**Comment Summary – January 13, 2025 (5<sup>th</sup> Submission)**  
**Zoning By-law Amendment Application – WDD Main St. Inc.**

RE: **NPG Comments  
Main St  
RE: Application for Zoning By-law Amendment & Draft Plan of Subdivision**

**Re: Zoning By-Law Amendment 5th Submission  
11 Main Street (Morrison)  
Puslinch, ON**

**RE:** Hydrogeological Review Comments - 5th Submission  
WDD Main Street Inc. - 11 Main Street, Morriston (Puslinch), Ontario  
Proposed Residential Subdivision  
Zoning By-law Amendment / Draft Plan of Subdivision Application

Drawing  
**POST-DEVELOPMENT DRAINAGE PLAN**

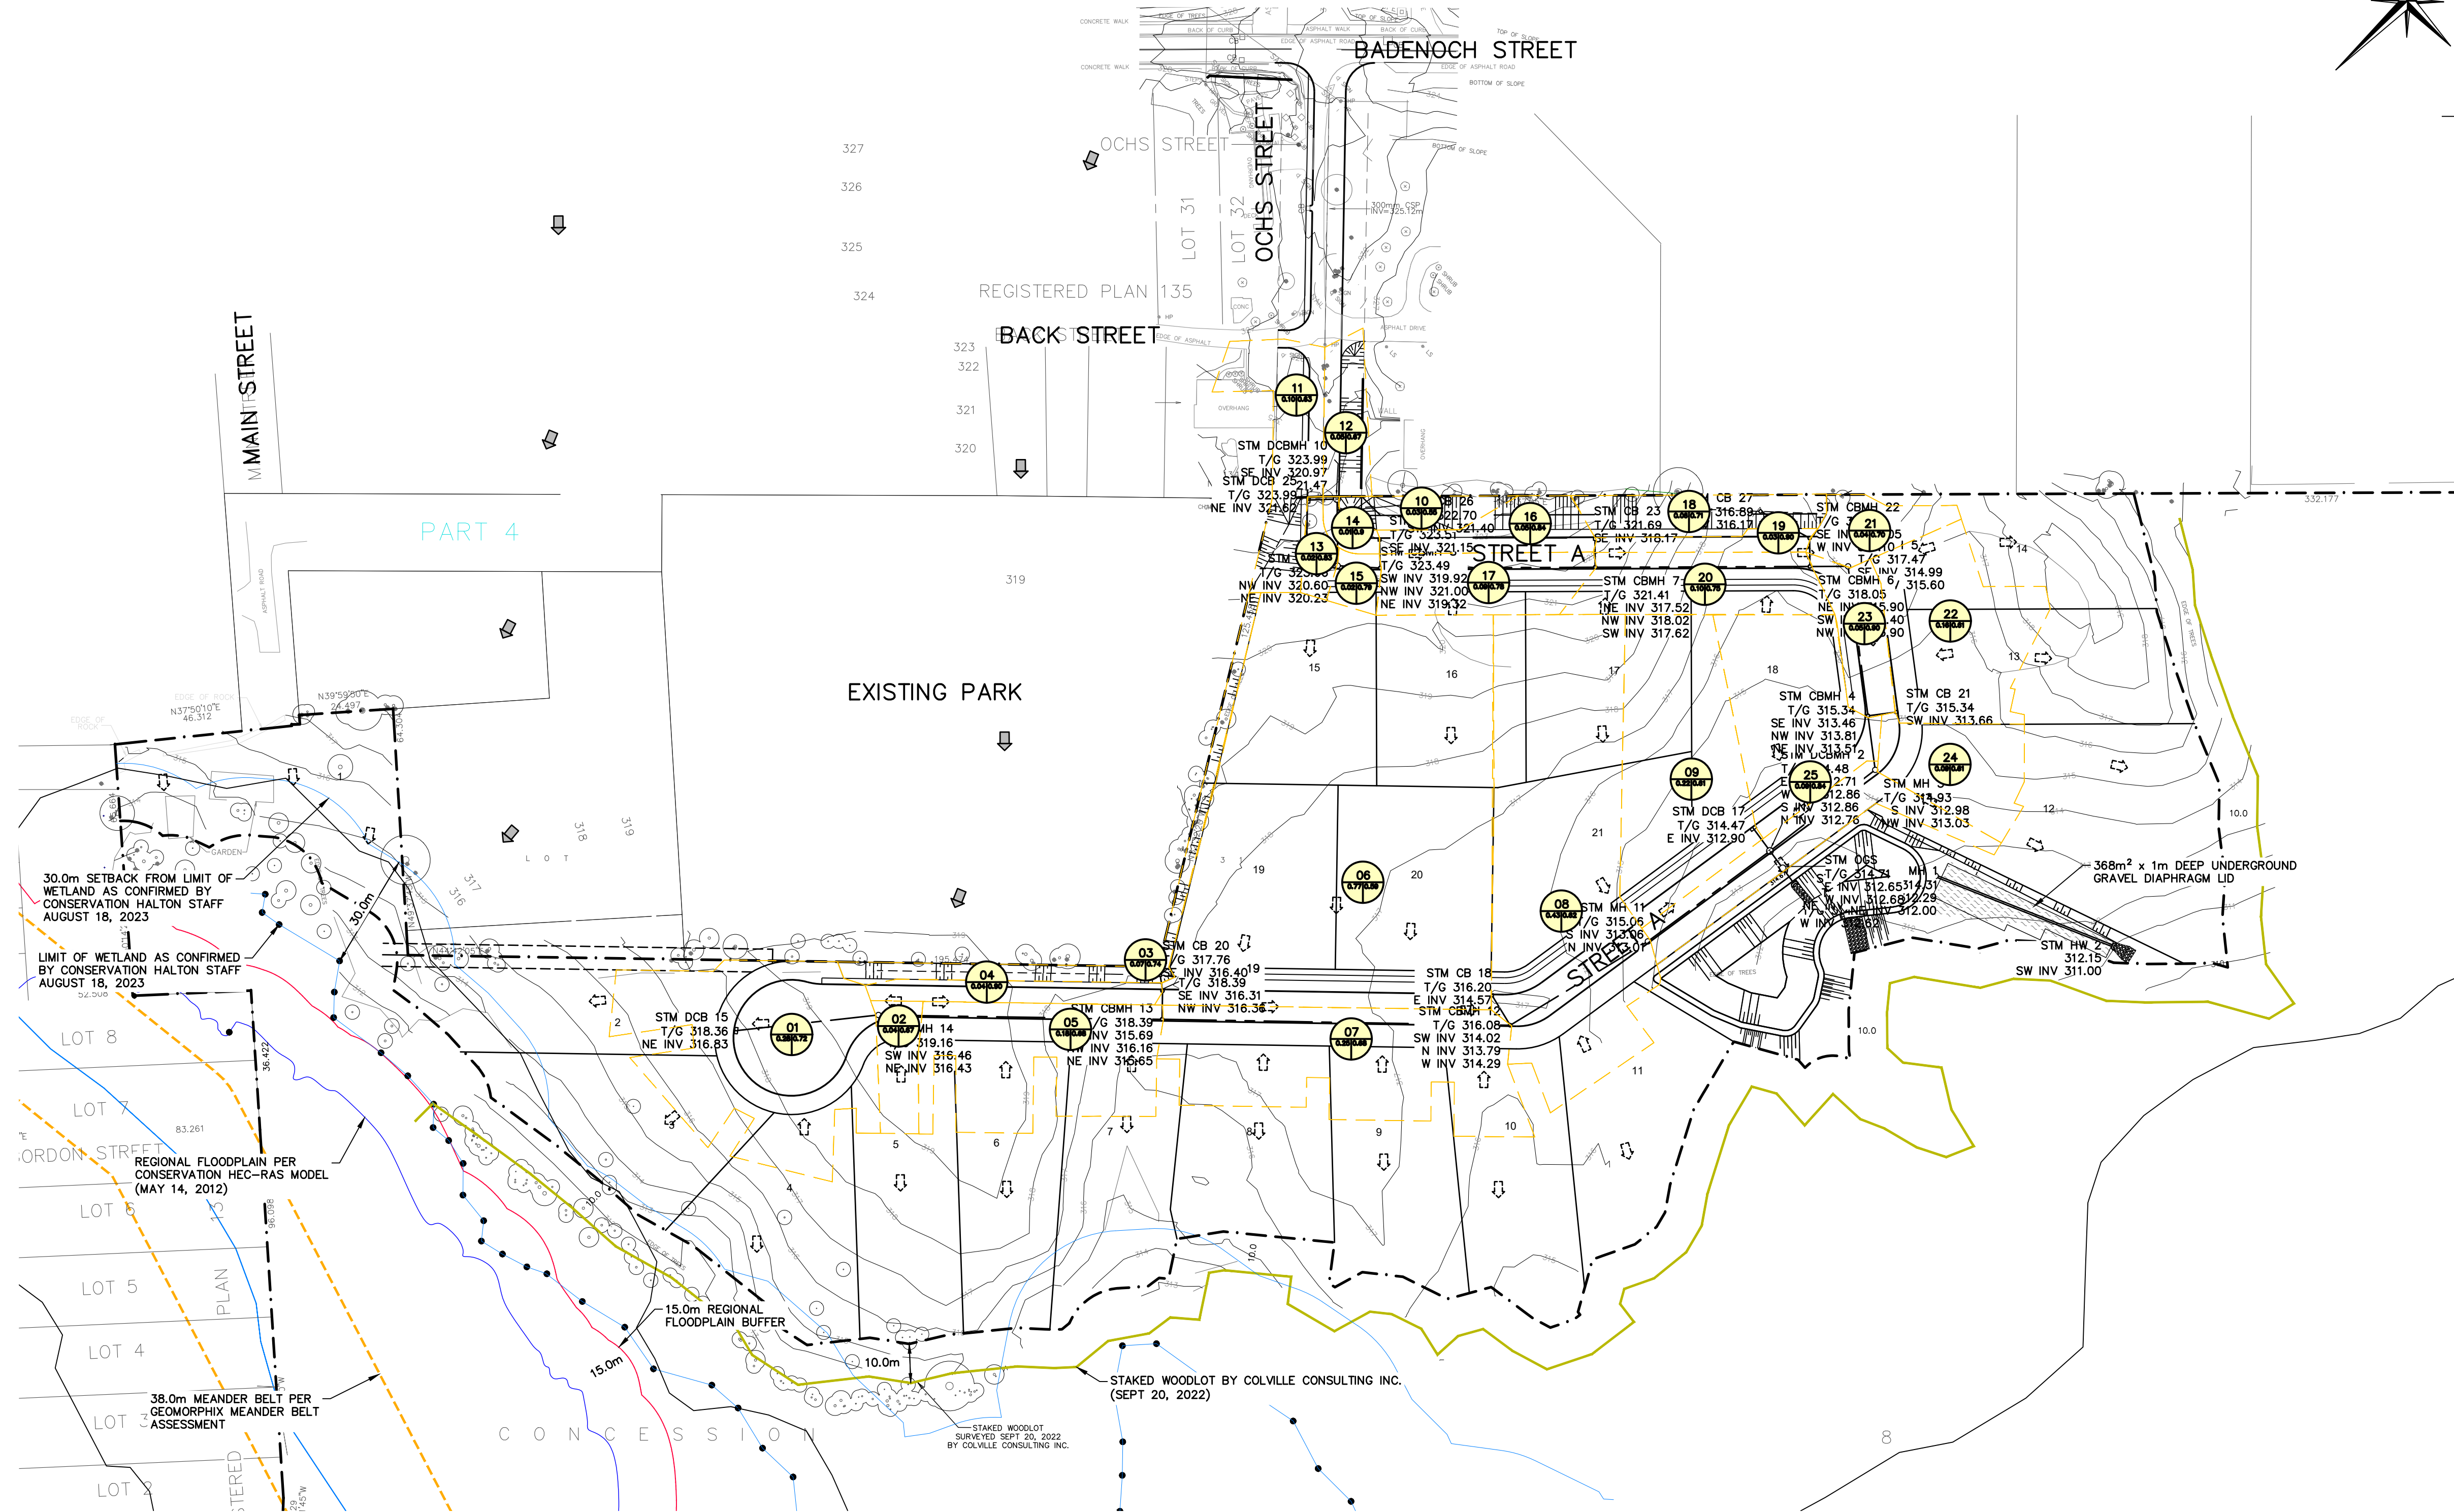
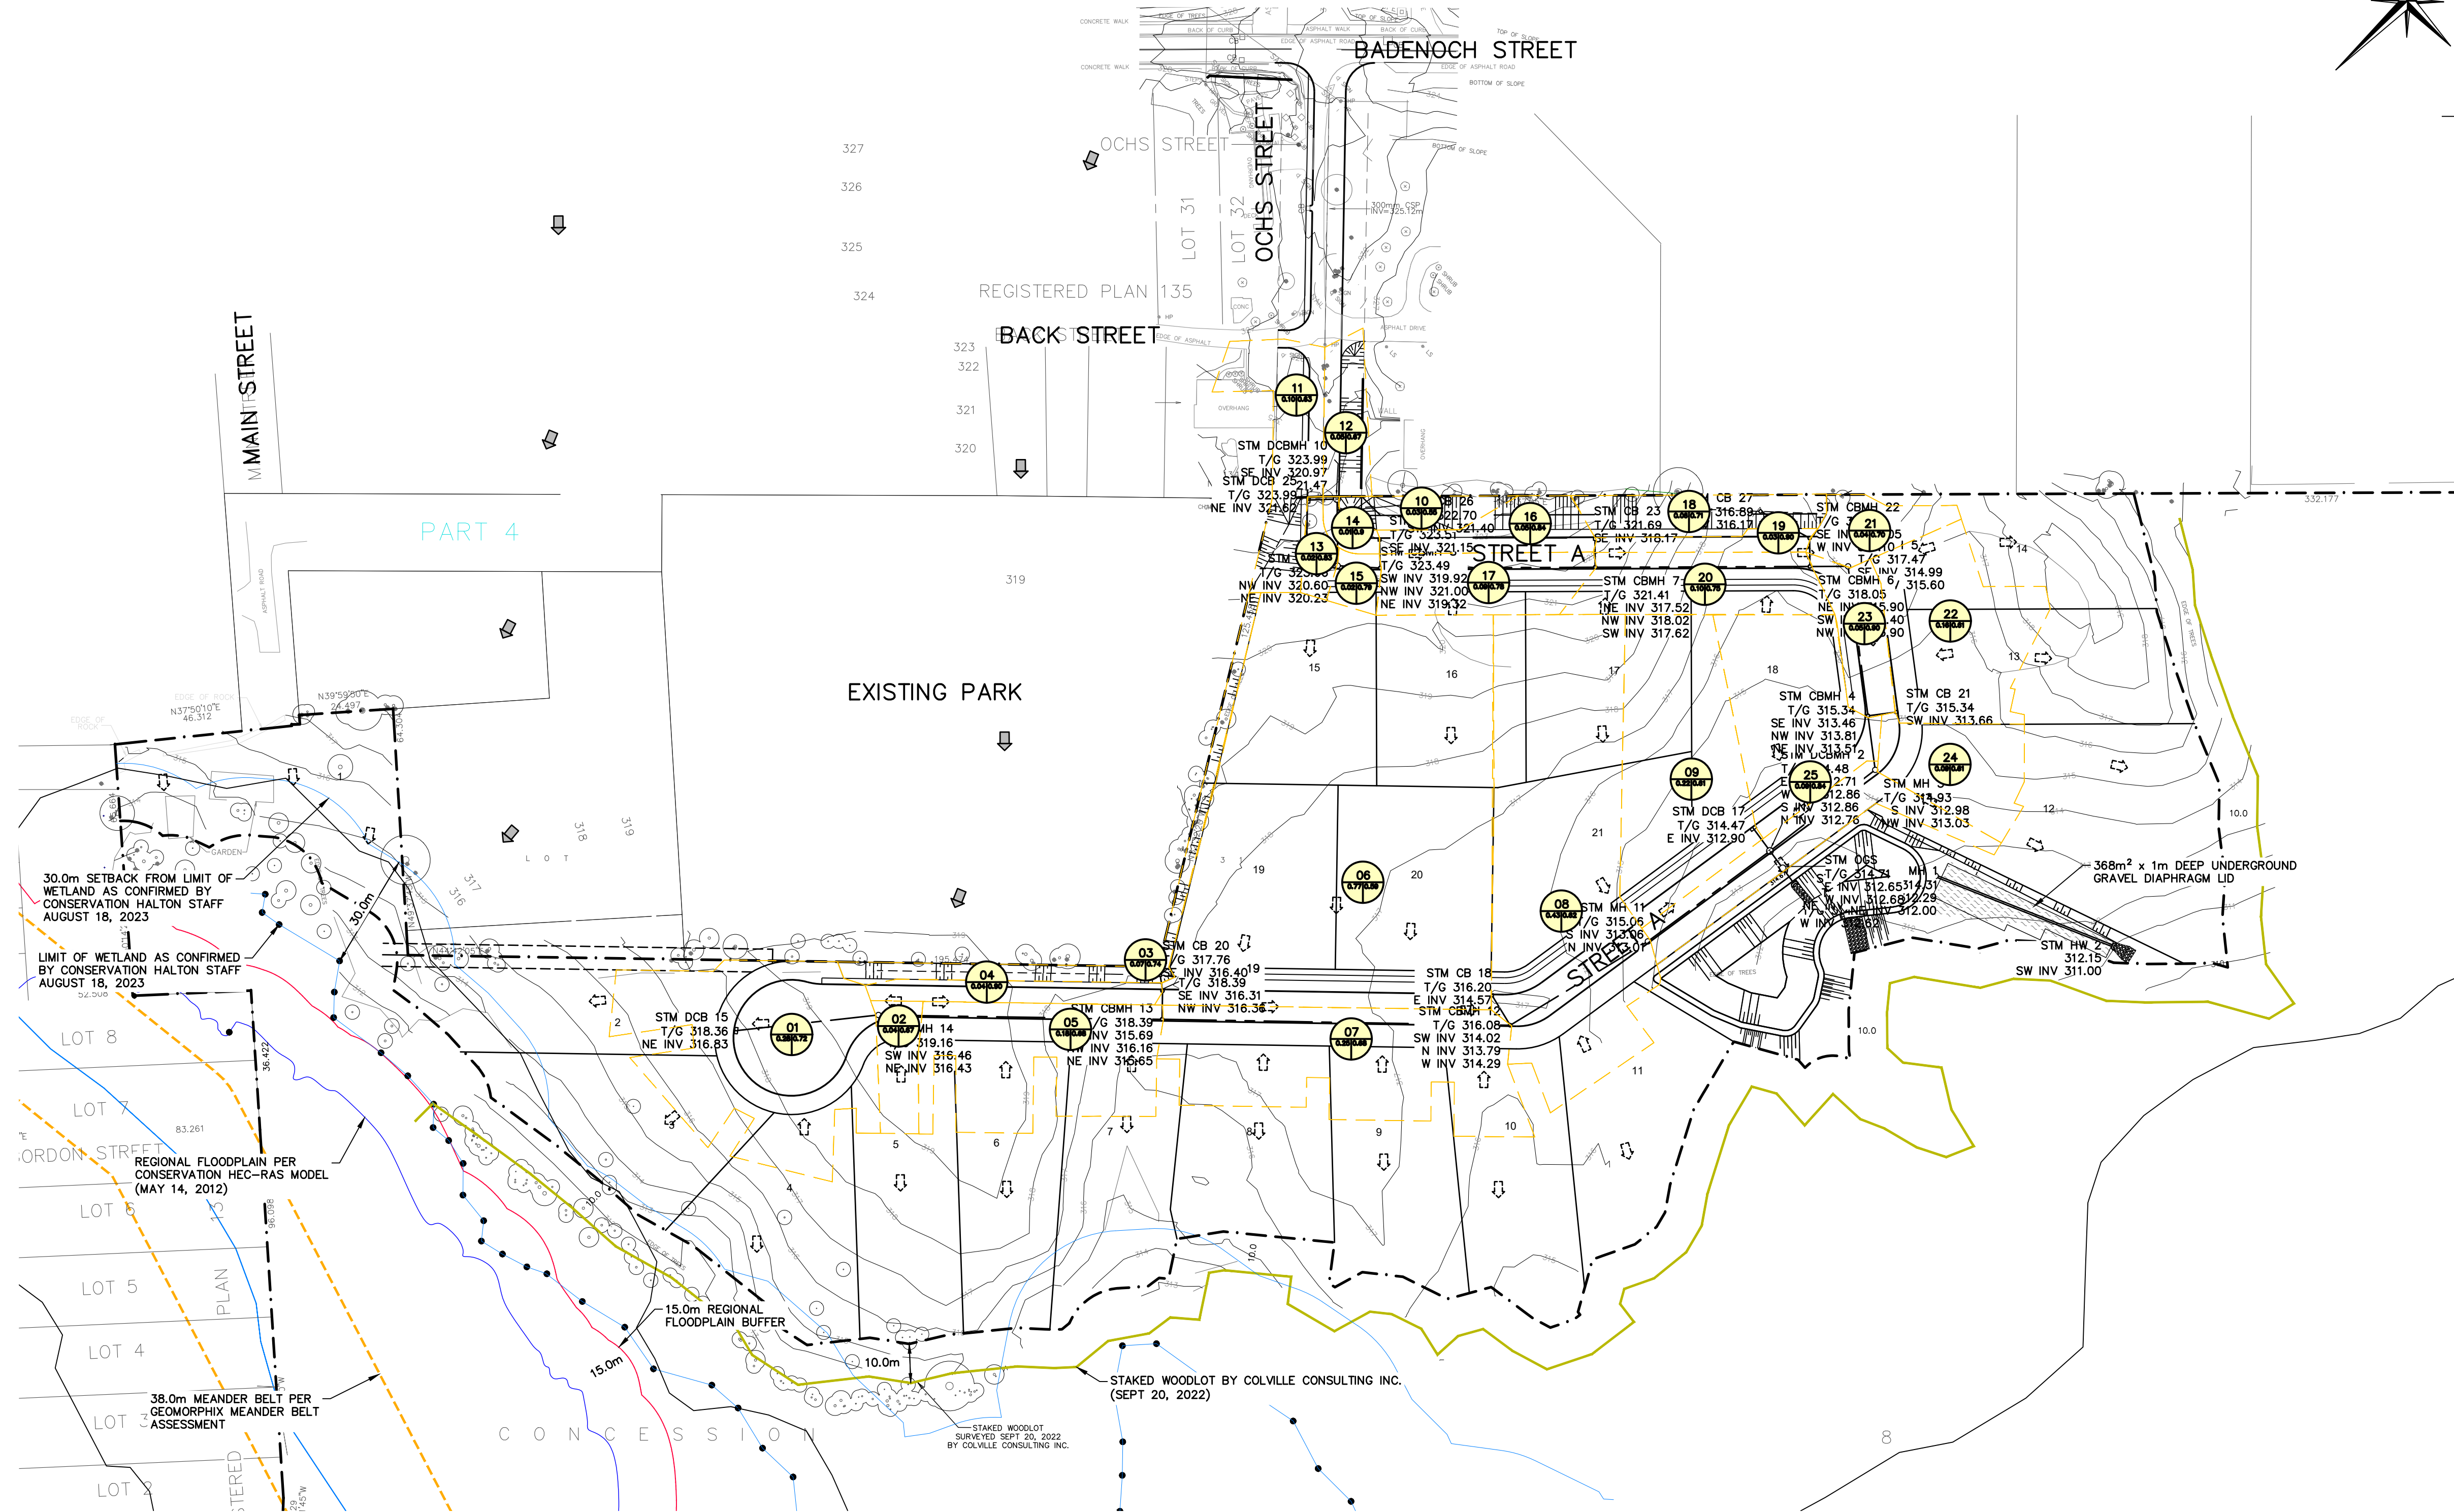
6.	Post-Development Drainage Plan	FSR	April 20, 2023	<p><u>GEI Comment (April 20, 2023)</u>            Please label the imperviousness of the external areas on the Post-Development Plan for consistency.</p> <p><u>Crozier Response (January 2024)</u>            The Post-development Drainage Plan has been revised to include the imperviousness of the external drainage catchments.</p> <p><u>GEI Comment (February 9, 2024)</u>            Accepted, no further comment.</p>
